THE AMERICAN RAILWAY ENGINEERING AND MAINTENANCE  
OF WAY ASSOCIATION

**Committee:** 4 (Rail), **Subcommittee:** 6 (Joint Bars, Insulated Joints, Track Bolts, Spring Washers)

**Letter Ballot Number:** 04-21-03

Figure 4-3-8. Recommended Rail Drillings and Bar Punchings for 115 RE, 119 RE, and 133 RE Utilizing 1 Inch Track Bolts

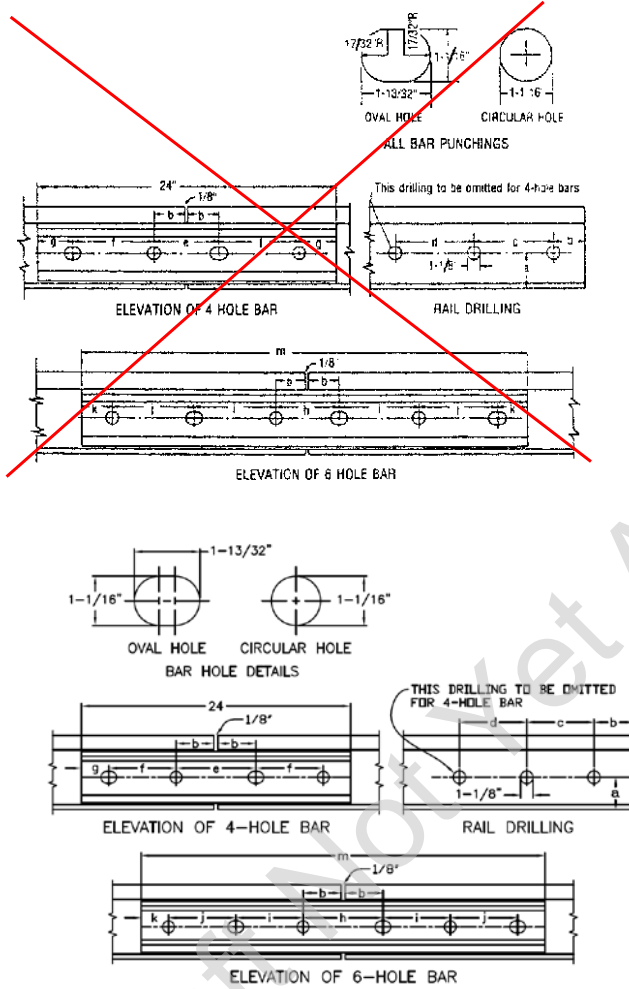
This ballot was a result of general review of Section 3.3. It was concluded that in Section 3.3 Table 4-3-1, all references to 140RE should be removed as it is no longer a contemporary rail section. In this table, Note 2 will be added to clarify the calculation of proper hole spacings for insulated joint bars. Updated and corrected figures for Recommended Rail drillings for 115RE, 119RE, 132RE, 136RE, 141RE and 133RE will be added.
